VARSITY LINCOLN INVENTORY LOT JSP19-15

Consideration of the request of CityScape Architects for Preliminary Site Plan and Stormwater Management Plan approval. The subject property is 6.1 acres and is located in Section 17, on the east side of Wixom Road and south of Grand River Avenue. The property is zoned B-3 General Business. The applicant is proposing to repurpose a portion of the existing parking lot on the west side of the site to accommodate additional vehicle inventory parking for the existing vehicle dealership.

Approve/Deny the Preliminary Site Plan and Stormwater Management Plan.

PLANNING REVIEW

FILE	C3-0.DWG
DESIGNED BY	ADG
DRAWN BY	ADG
CHECKED BY	ADR
DATE	FEBRUARY 19, 2019
SCALE	1" = 40'
HP	N/A
PROJECT NO.	2240
SHEET NO.	C3.0

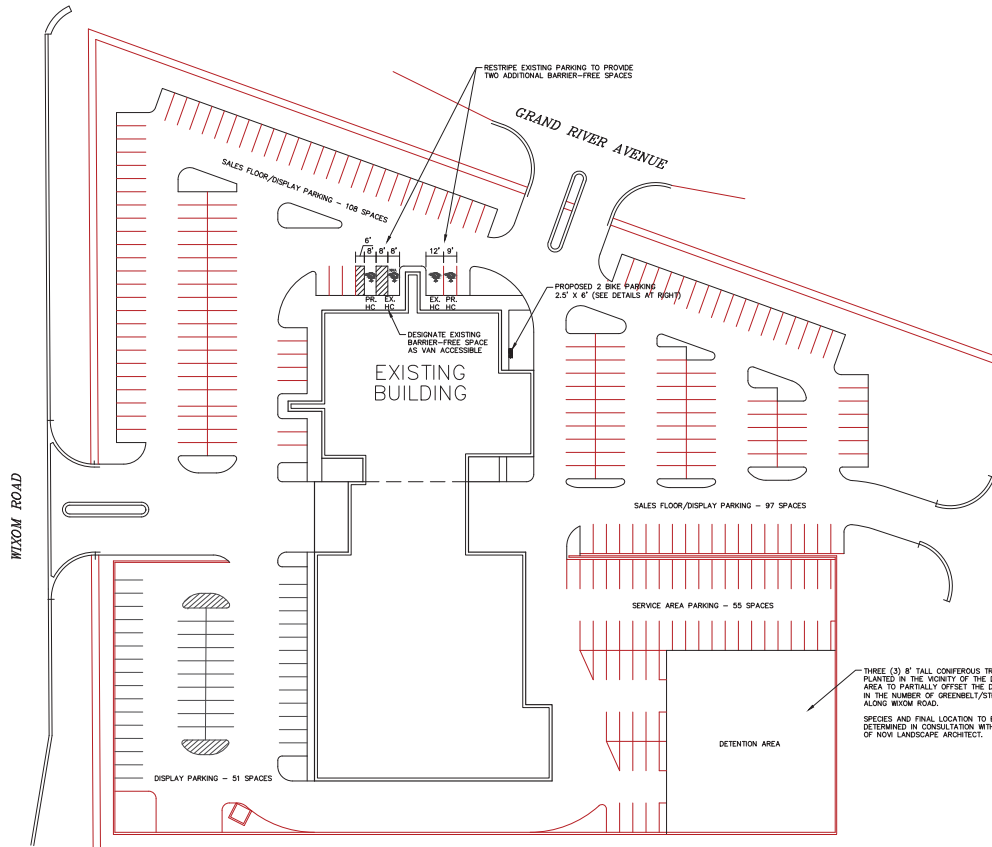
8. The City standard straight-faced curb (MDOT F-4 curb detail) shall be provided. Revise details accordingly.
9. Remove pavement details on sheet C3.0 that conflict with City Standard Details.
10. Provide a line of designation representing the effective 19-foot stall length for 17-foot perimeter stalls.
11. Curbing and walks adjacent to the end of 17-foot stalls shall be reduced to 4-inches high (rather than the standard 6-inch height to be provided adjacent to 19-foot stalls). Provide additional details as necessary.
12. Label the actual usable length of the proposed angled parking stalls. This is done by measuring between parallel lines representing the position at the front and rear of the car, without the rear of the car conflicting with the maneuvering aisle.

- b. Hours of lighting operation (dusk to dawn) are noted on Sheet C3.0.
 - c. Light fixtures in the subject area of the site have been modified to comply with the "not to exceed" requirement (4:1 ratio for average and minimum light levels to lowest light of surface being lit). The power plan was revised to reflect the changes in the light fixtures.

FILE	L1-0.DWG
DESIGNED BY	GL
DRAWN BY	GL
CHECKED BY	AGB
DATE	FEBRUARY 19, 2019
SCALE	1" = 20'
HR.	N/A
PROJECT NO.	2240
SHEET NO.	L1.0

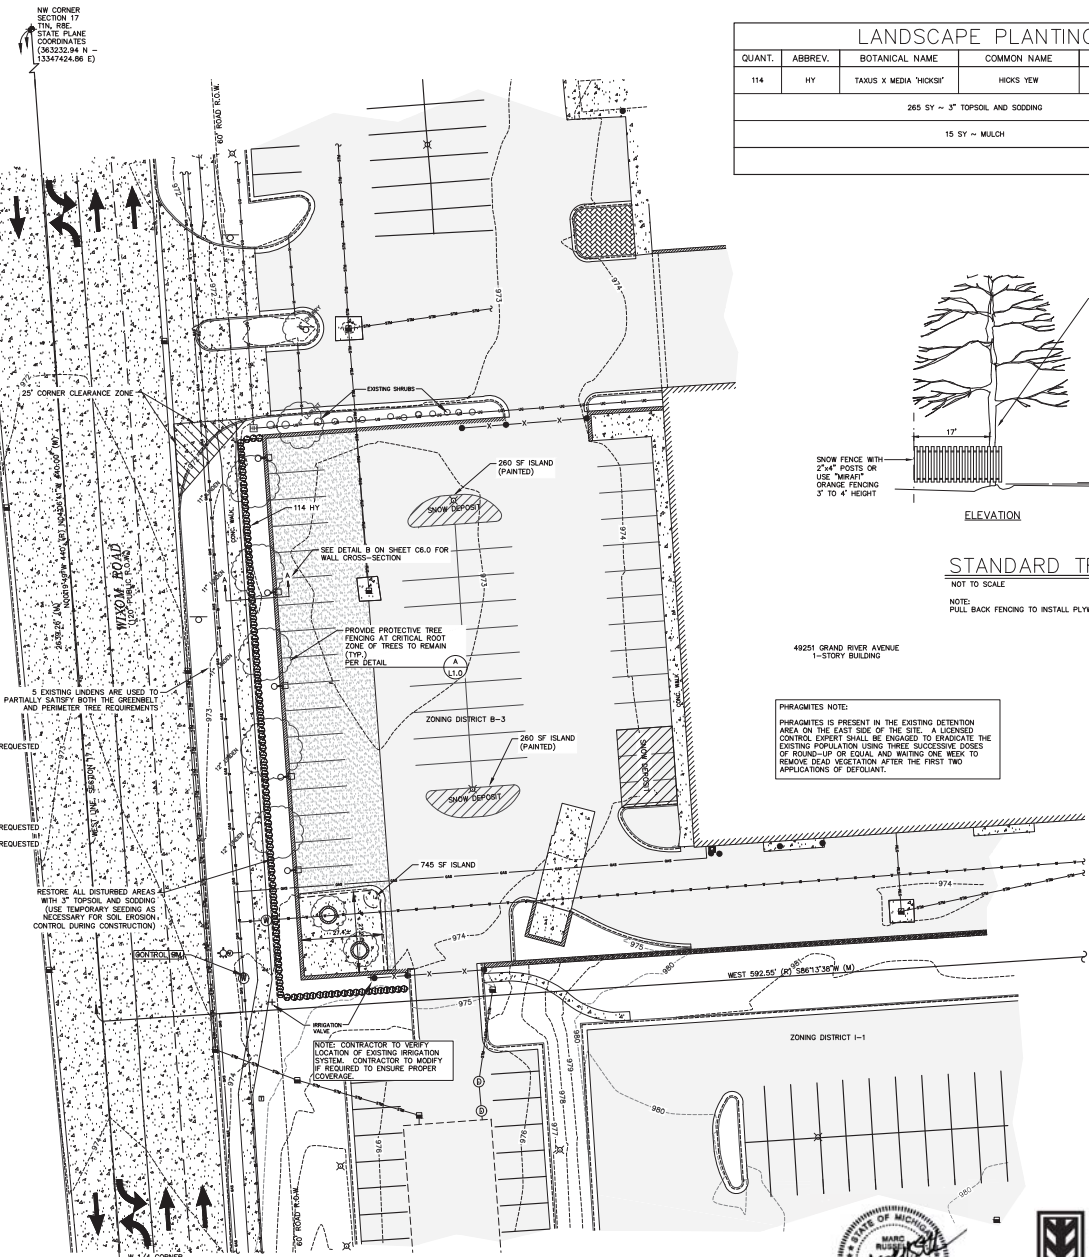
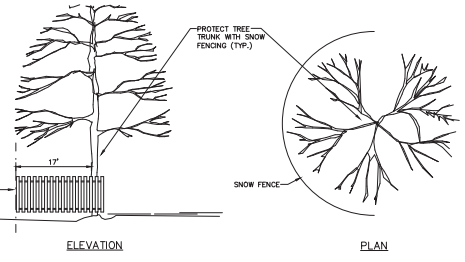
1. No changes to the basin are proposed so no new landscaping is required.
2. **Please add to the Phragmites note a statement that treatments in subsequent years may be required to fully eradicate the Phragmites.**

2. Lack of greenbelt berm – 3 foot tall berm is not provided ~~and remaining wall/berm/shrubs do not provide the required 3 feet of height. The waiver request is not supported by staff.~~ ***This waiver is now supported by staff as a continuous 36" hedge to screen the parking lot is now provided.***

1. A registered landscape architect (Mr. Marc Russell—his contact information and stamp are found on sheet L1.0) was engaged to supervise modifications to the landscape plan.

2. Zoning of the adjacent parcel to the south is shown on Sheet L1.0.
3. The corner island, interior to the parking area, and its two trees will NOT be removed. Dimensions and area in SF for this island are also included.

5. Snow deposit areas are shown on Sheet L1.0.
6. Calculations are shown for ROW landscaping, interior landscaping and building foundation landscaping. Several waivers are requested further below for apparent deficiencies.

7. Mr. Russell found that Phragmites was present in the detention area. Therefore, a note is included on Sheet L1.0 indicating appropriate eradication measures.

12. Mulch is added to the planting schedule (Sheet L1.0) at \$35/SY.
13. A protective fencing detail is provided on Sheet L1.0 for use with the existing trees along Wixom Road.
